CHANGE ORDER Equipment Credit, IL-3& IL-4 Sheet Revisions

No. 4

PROJECT: **MEYERS ROAD EXTENSION**

Contract Change Order No. 4

DRAWING NUMBER:
IL-3
 SHEET OF

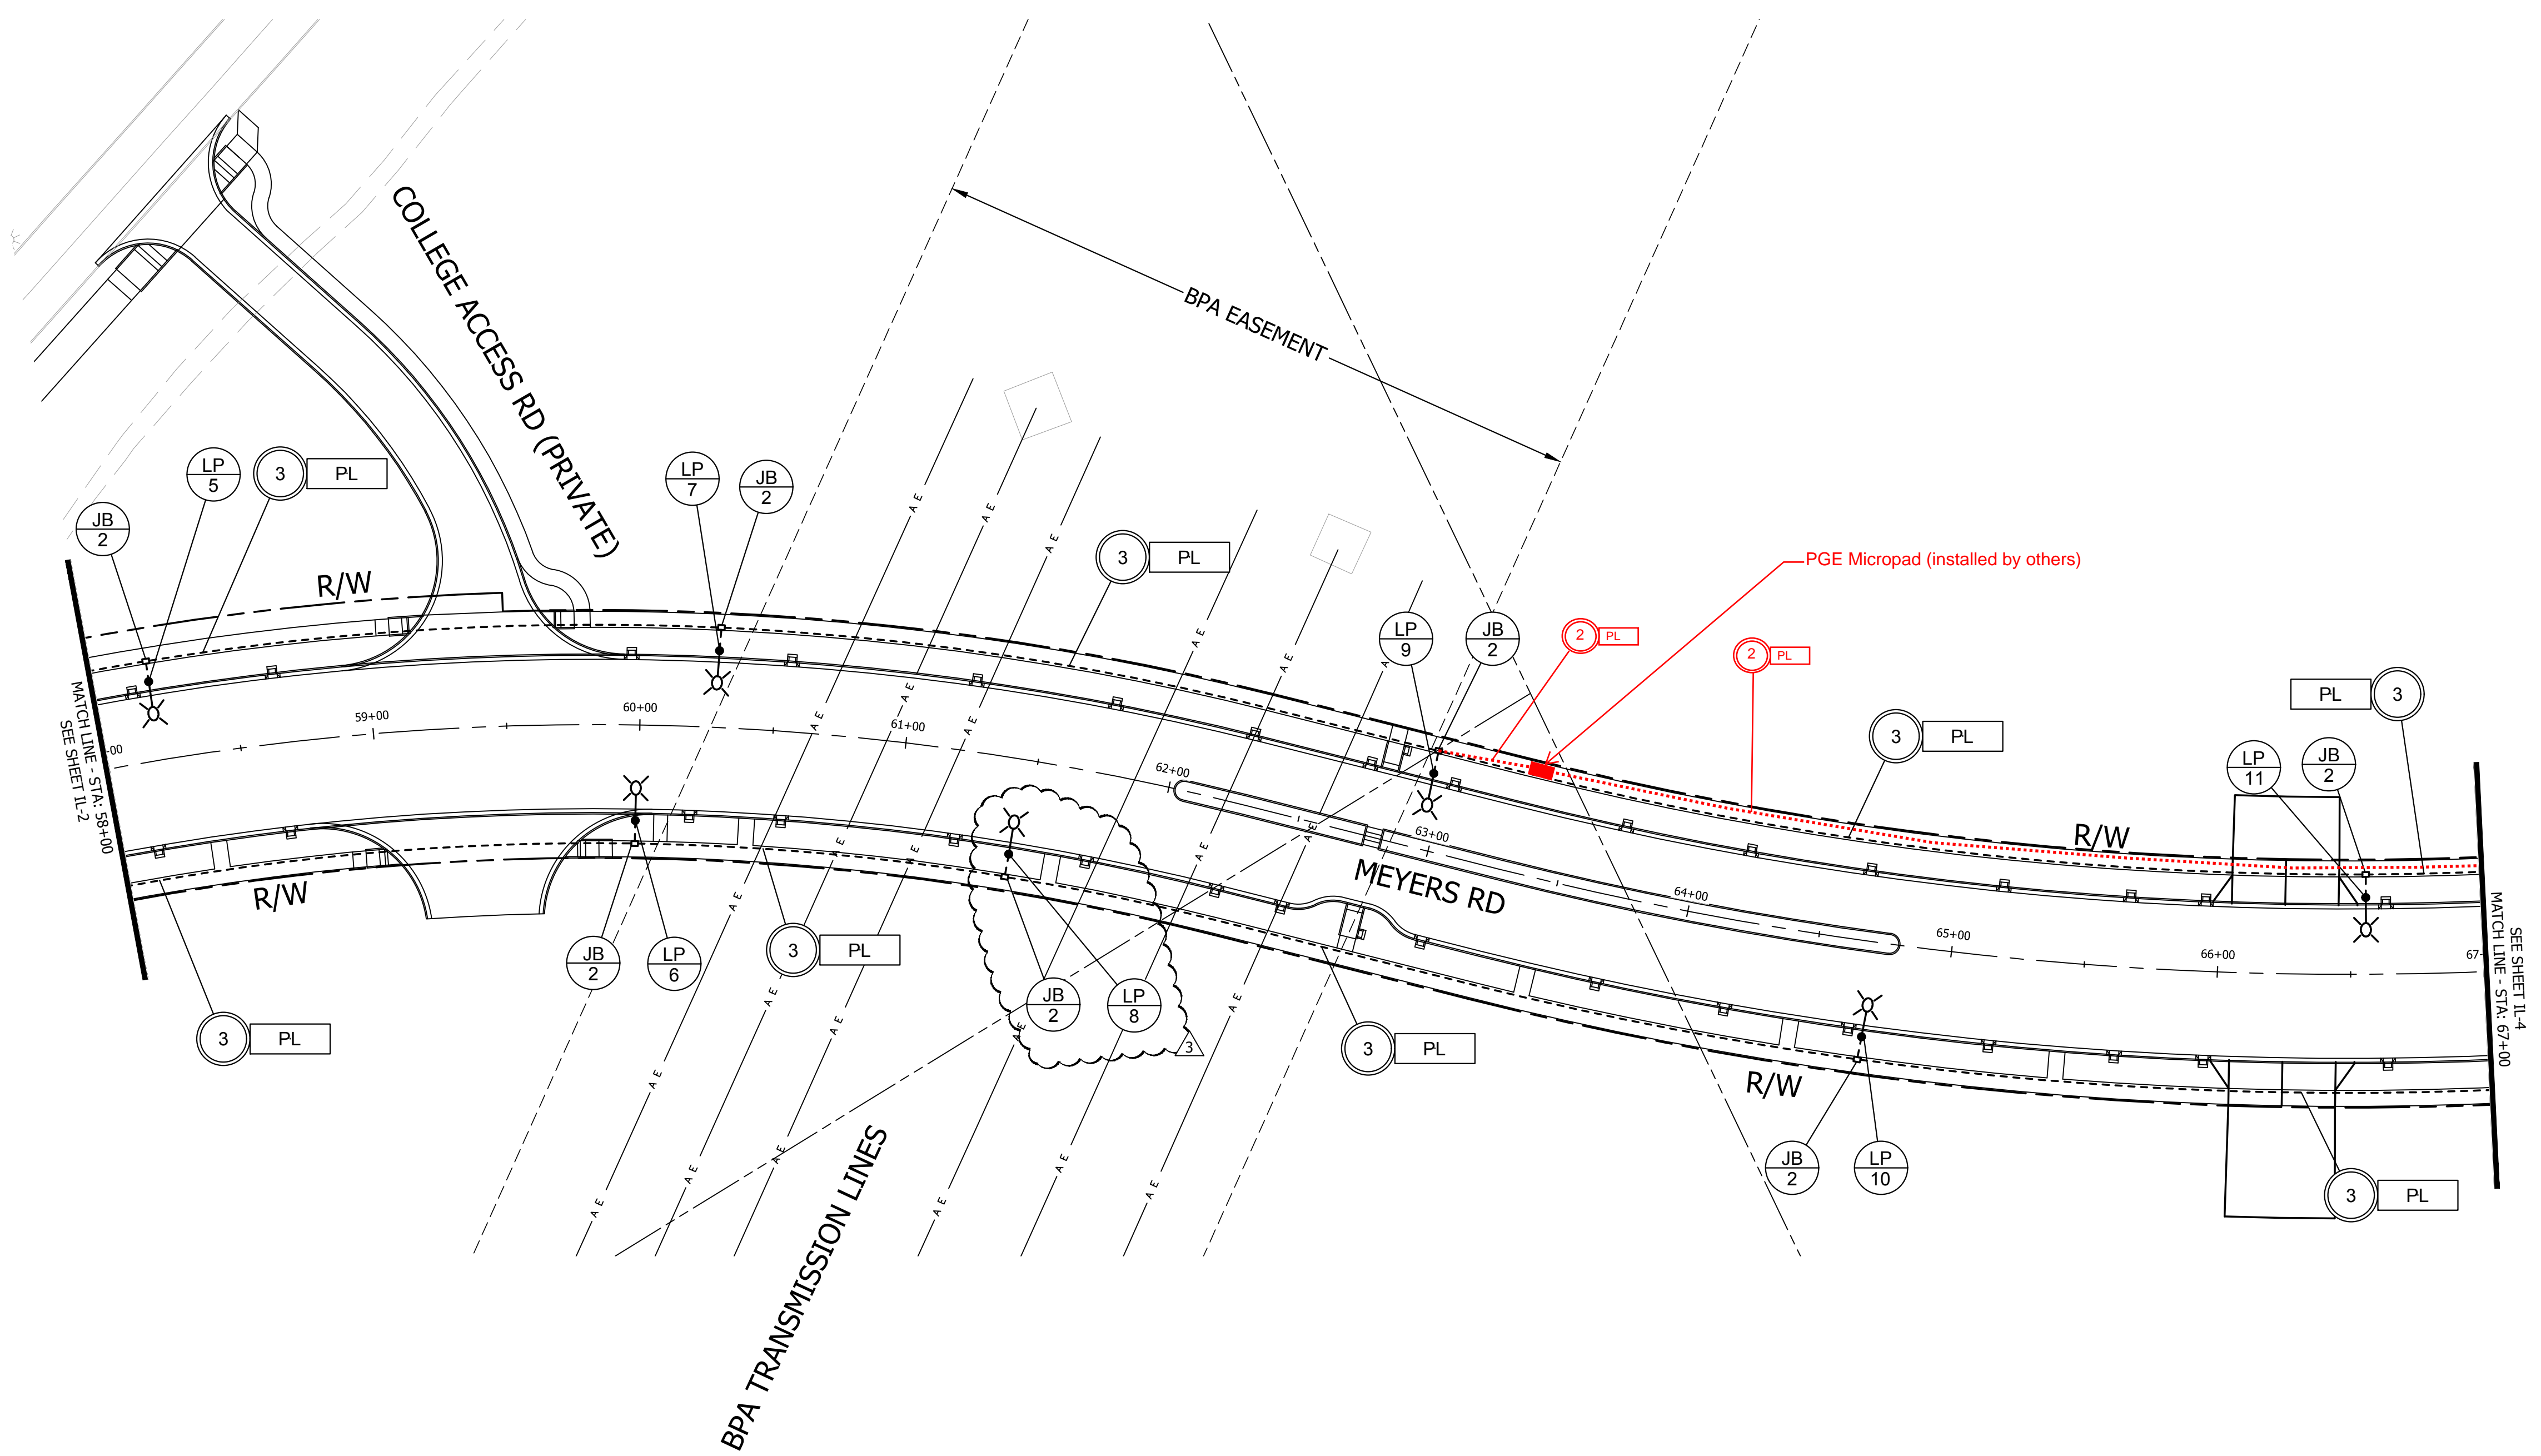
4004A: This change order compensates the contractor for the power service connection for the street lighting (illumination) as required by PGE. The revised plans were sent to Aaken for pricing (see Attachment 2, revised sheets IL-3 and IL-4). Their costs make up the majority of the change order along with a couple hours of superintendent time to cover Canby Excavating costs for the additional work.

4004A: The electrical service connection for the street lighting was not included in the contract at the time of bid. It was not included in the bid package because PGE did not have their design completed at the time of bid. Sheets IL-3 and IL-4 were marked up accordingly and provided to the Contractor. A price proposal was requested from the Contractor for the additional work and upon receipt, it was reviewed by the Engineer and compared to the on-site Inspector's daily records. A negotiated price was then agreed to between the Engineer and Contractor.

REV. NO.	DATE	DESCRIPTION
3	07/31/19	Light Pole & Revision
4	12/10/19	Additional 2 inch Conduit

- Approximately 950 feet of directional drilling
- Prep for micropad
- Connection to existing vault

DRAWING NUMBER:
IL-4
 SHEET 113 OF 147

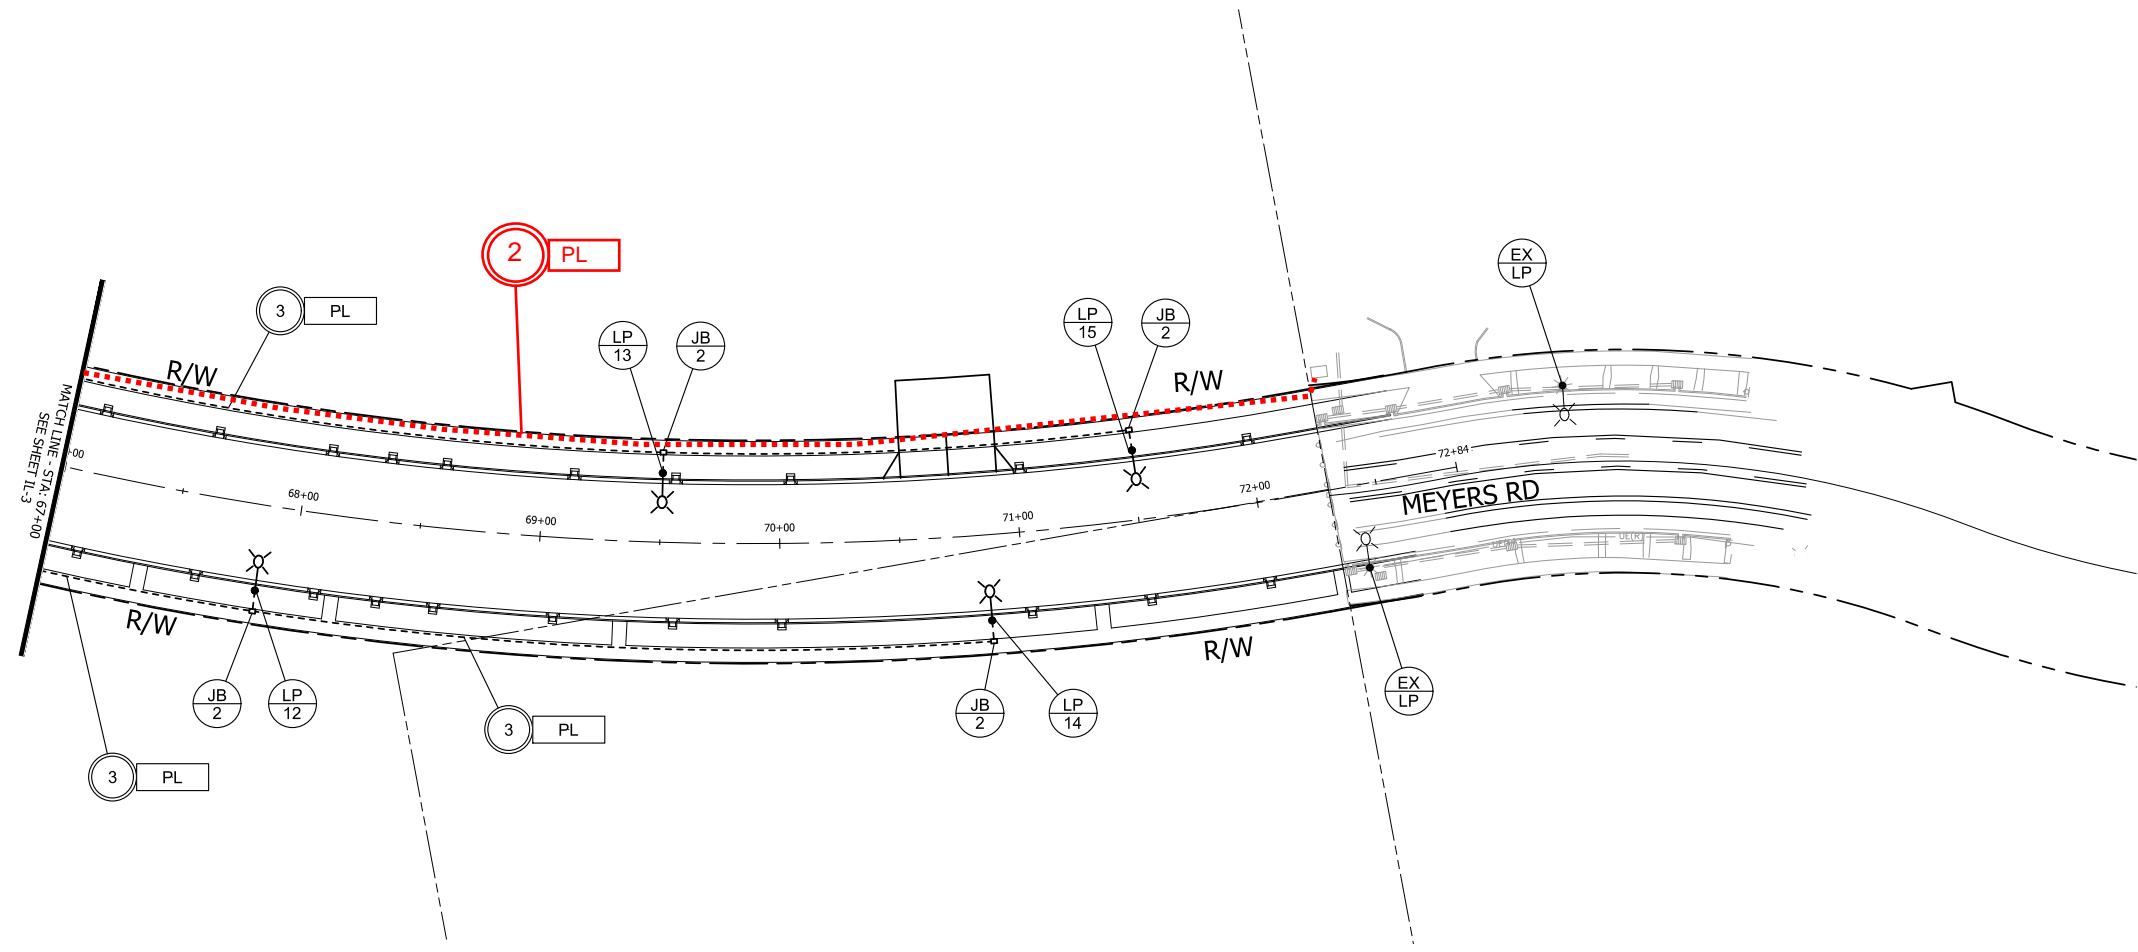
REV. NO.	DATE	DESCRIPTION
4	12/10/18	Additional 2-inch Conduit

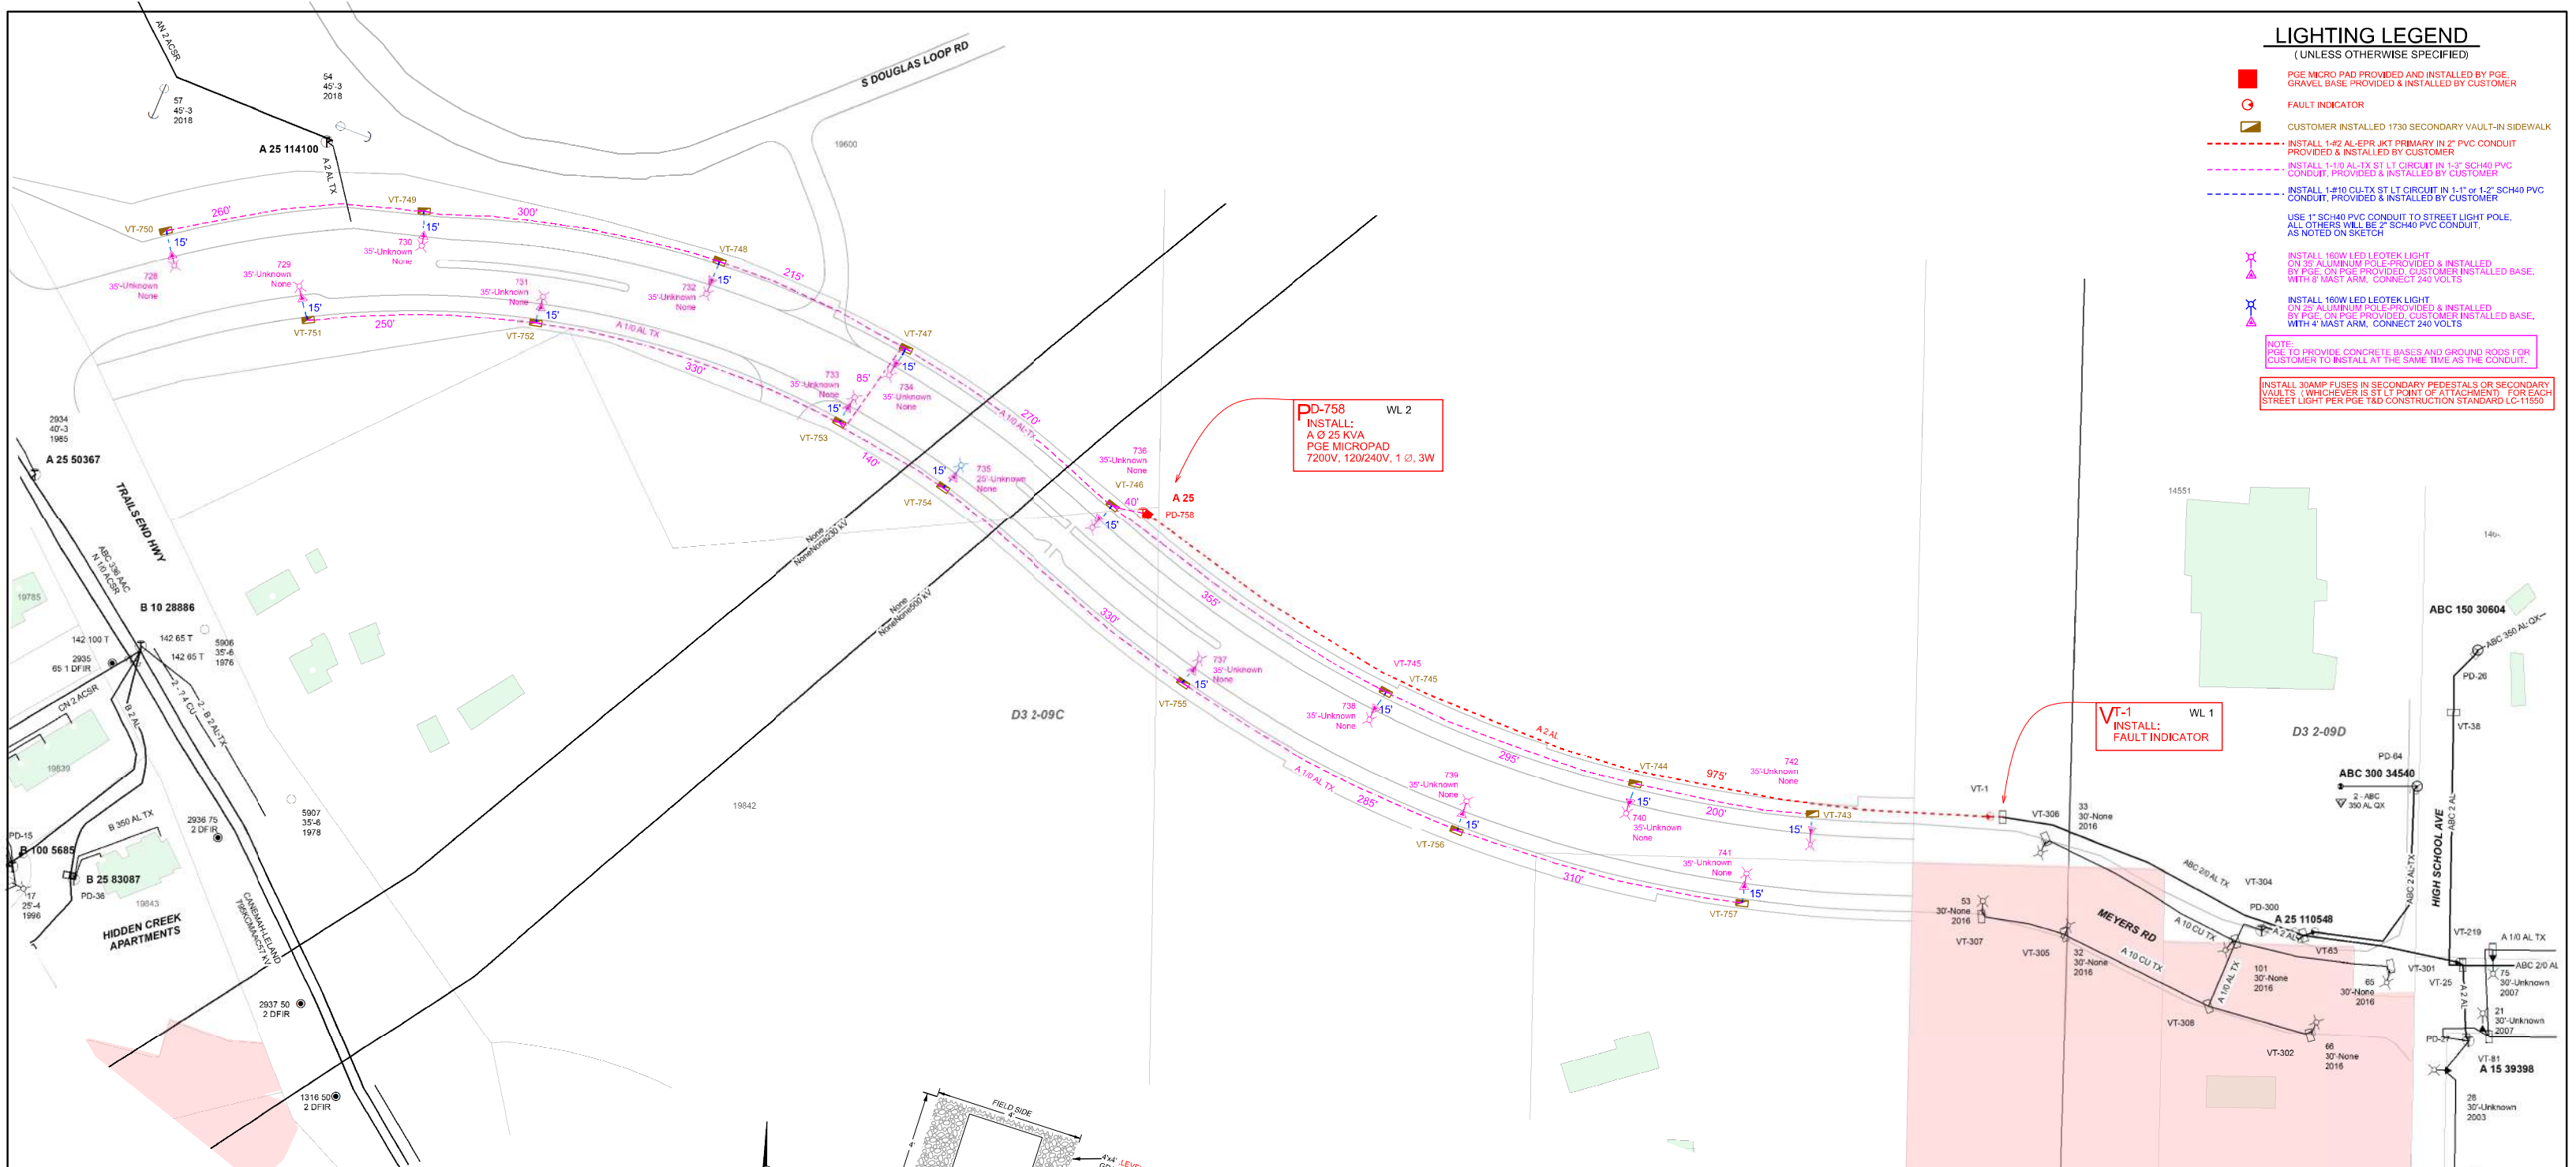
Description of Change: Install conduit and micropad base per revised IL-3 and IL-4 drawings (revision dated 12/19/19)
